**AMENDMENTS TO THE DRAWINGS:**

**REMARKS**

Fig. 4

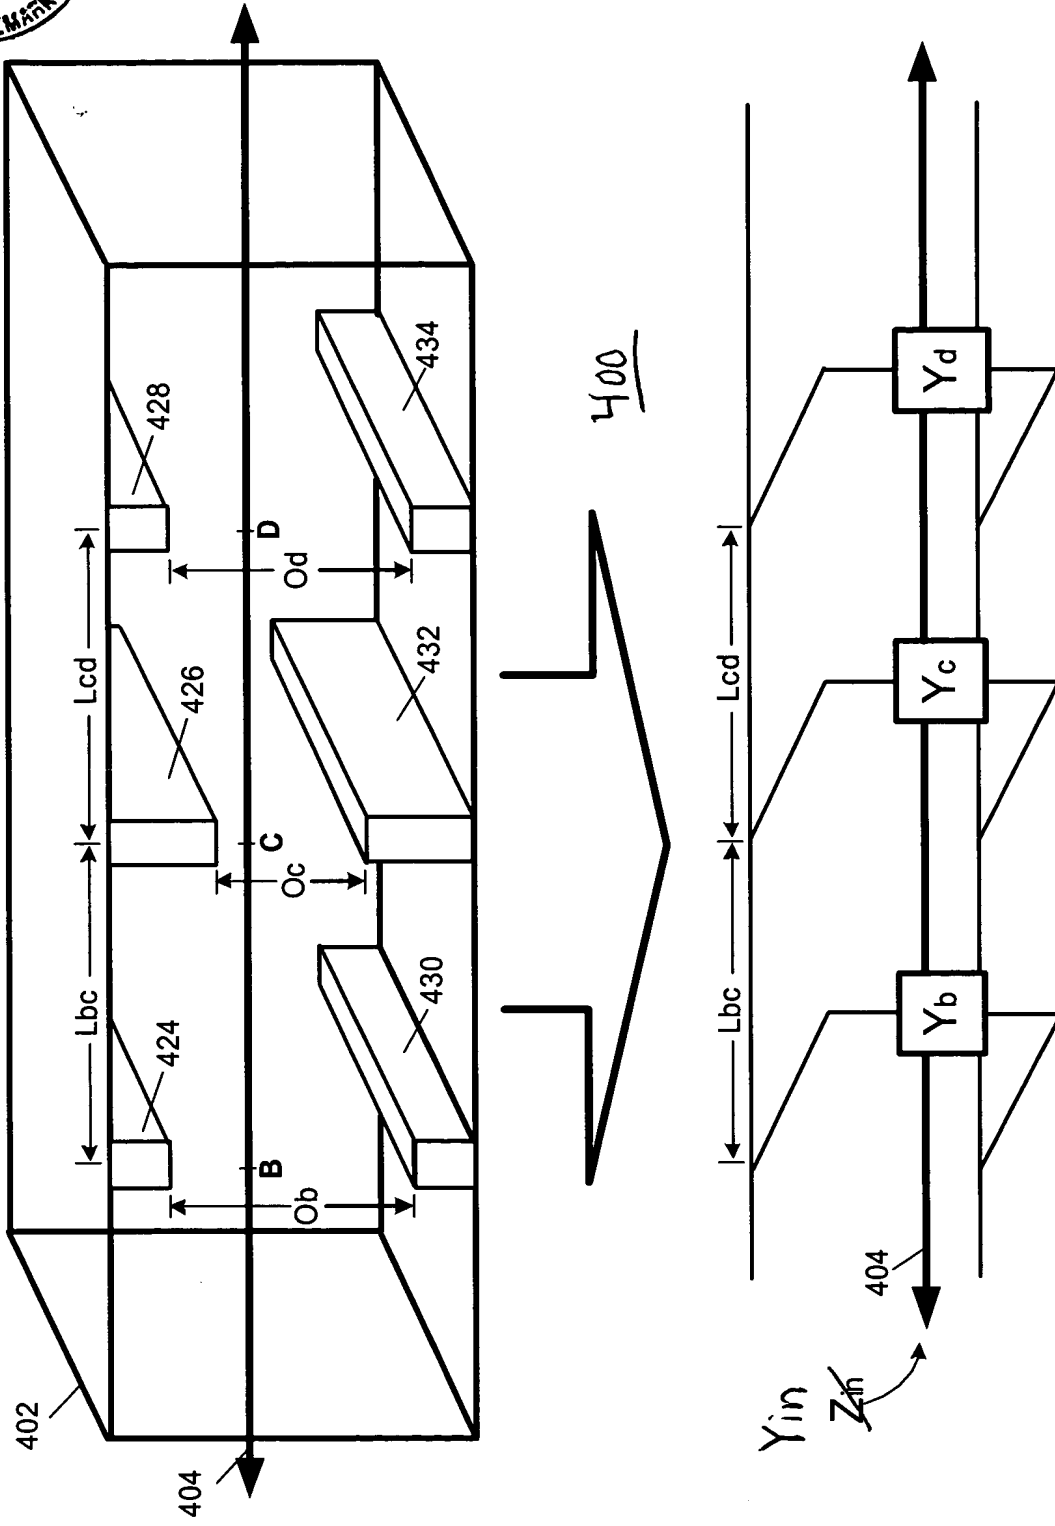
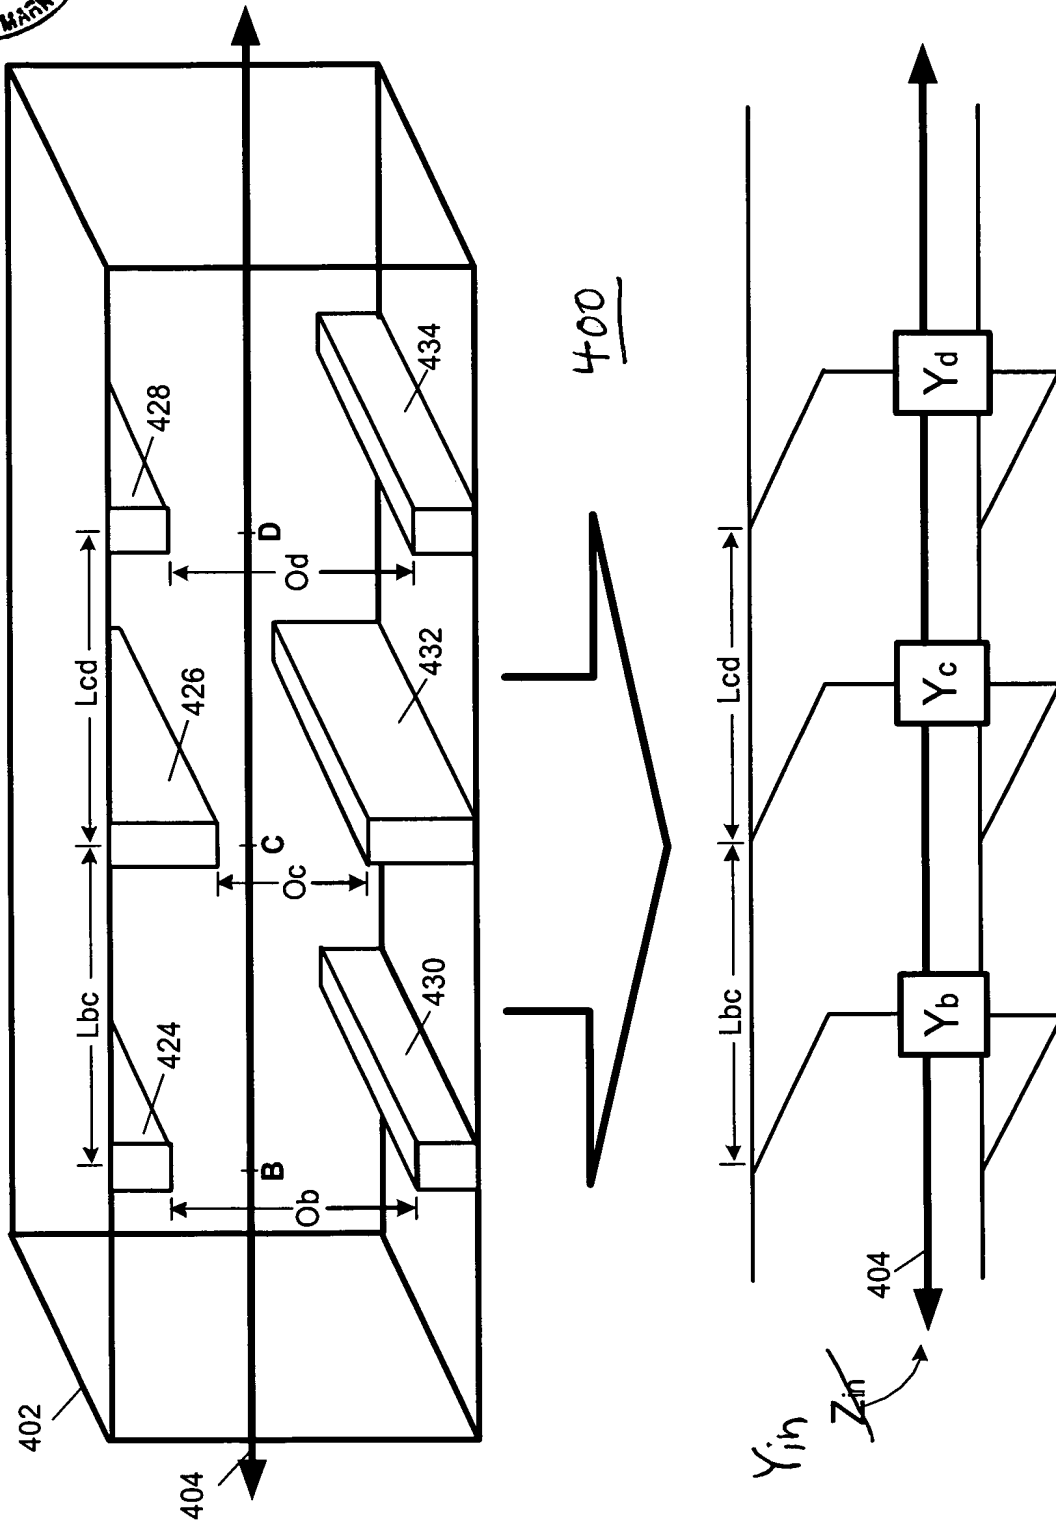
The attached sheets of drawings includes changes to Figs. 1 and 4. These sheets, which include Fig. 1 and Fig. 4, replace the original sheets including Fig. 1 and Fig 4. In Fig. 1, reference item 126 under reference item 110 has been changed to --128-- to correct a typographical error. (See paragraph [0022].) In Fig. 4, the reference character --400-- has been added, as required by the Examiner on page 3 of the Office Action and described in paragraph [0022] of the Office Action. Also in Fig. 4, "Zin" has been replaced by "Yin" because the figure shows admittance along the waveguide path 404, as described in paragraph [0025] of the specification.

On page 3 of the Office Action, the Examiner notes that the reference labels Zin, Yb, Yc, and Yd, as depicted in Fig. 4, are not explicitly described in the specification. In response, paragraph [0025] of the specification has been amended to provide explicit description for the admittances Yb, Yc, and Yd shown in Fig. 4. The present response also includes proposed drawing changes in which the item "Zin," as shown in Fig. 4, has been changed to an admittance "Yin." Support for this change is found in original paragraph [0025], which describes an admittance "Y" along the waveguide path 404.

The Office Action includes an objection to the drawings because Fig. 4 does not show reference labels "400," "Y" and "L." In response, Applicants submit herewith proposed drawing change to Fig. 4 that includes the reference labels "400" and "Yin." As noted above,

Applicants' proposed changes to Fig. 4 include replacing "Zin" with "Yin" and have amended the reference "Y" to "Yin" in the specification because the original specification describes Fig. 4 as showing admittance along the waveguide path 404. Applicants have removed the reference to "L" in the specification because it is believed that the description in paragraph [0025] of separations between openings refers to the exemplary separations "Lbc" and "Lcd" would render redundant such inclusion of an additional label "L."
